STS Hydropower, LLC, a subsidiary of Eagle Creek Renewable Energy, LLC, and the City of Danville, Virginia are co-licensees (The Licensees) of the Schoolfield Hydroelectric Project (FERC Project No. 2411). The Licensees are beginning the Federal Energy Regulatory Commission relicensing process. The hydroelectric project is located on the Dan River in Pittsylvania County, VA. The Licensees has identified you as a potential stakeholder, and kindly requests you review the attached document, and complete and return the included questionnaire no later than Monday, April 29, 2019. The completed questionnaire may be sent to Matthew Burak at mburak@louisberger.com. If you have any questions please do not hesitate to contact Matthew Nini at Matthew.Nini@eaglecreekre.com.

**Re: Request for Information for the Federal Energy Regulatory Commission
Relicensing of the Schoolfield Hydroelectric Project (FERC No. 2411)**

**Schoolfield Hydroelectric Project FERC No 2411
Pre-Application Document Stakeholder Questionnaire**

Revised Figure 3.4.4-1. Proposed Roanoke logperch sampling reach within the upper Project reservoir.

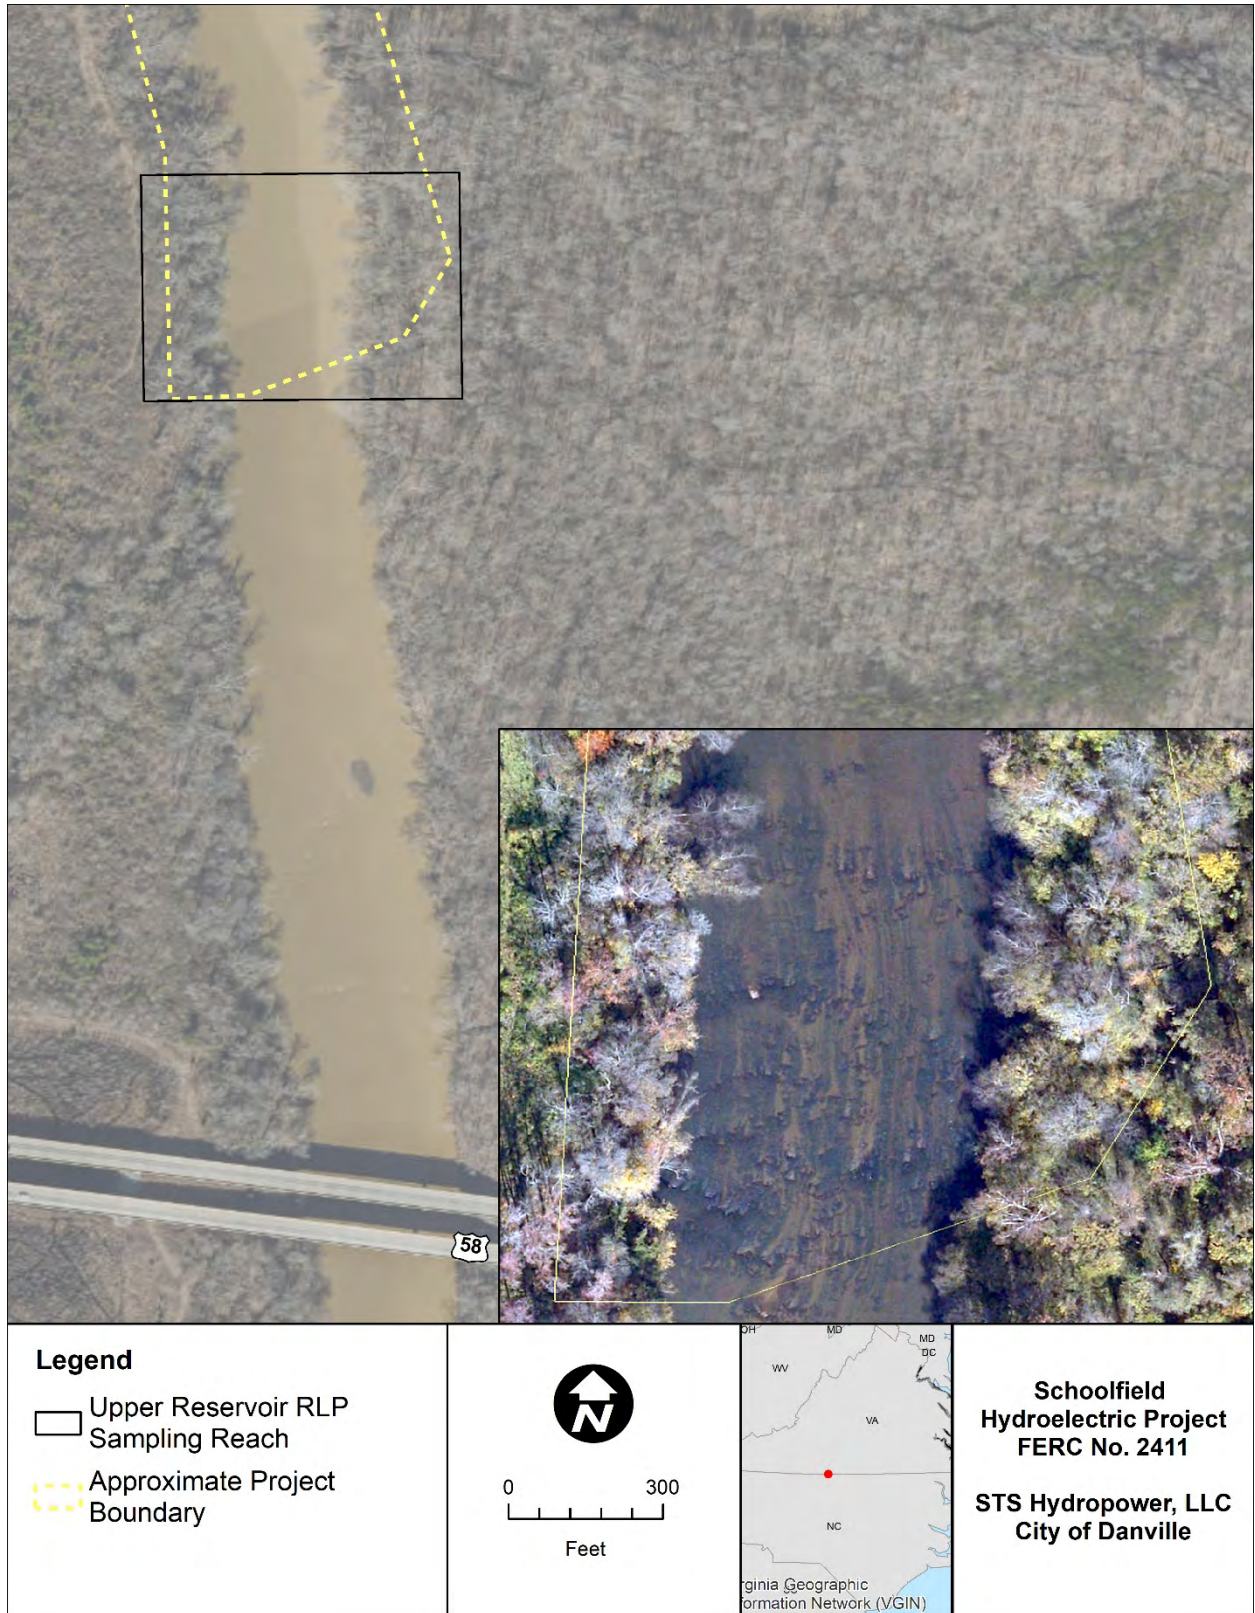
Figure 3.4.4-2. Proposed Roanoke logperch sampling reach within the upper Project reservoir, page 35: This figure shows the proposed RLP sampling location in the upper reservoir. Due to the scale of the figure, no reference points are available to determine the exact location of the sampling location. Provide either the distance from the Route 58 bridge or the global positioning system coordinates to enable identification of the exact location of the sampling location.

- 10) Figure 3.4.4-2 [of the FSP] shows the proposed RLP sampling location in the upper reservoir. Due to the scale of the figure, no reference points are available to determine the exact location of the sampling location. Provide either the distance from the Route 58 bridge or the global positioning system coordinates to enable identification of the exact location of the sampling location.

the likelihood of detecting RLP. A revised Figure 3.4.4-1 is provided at the end of this letter.

Response: A revised Figure 3.4.4-1 is provided at the end of this letter. The proposed survey location is approximately 0.3 river miles downstream of the U.S. Route 58 bridge.
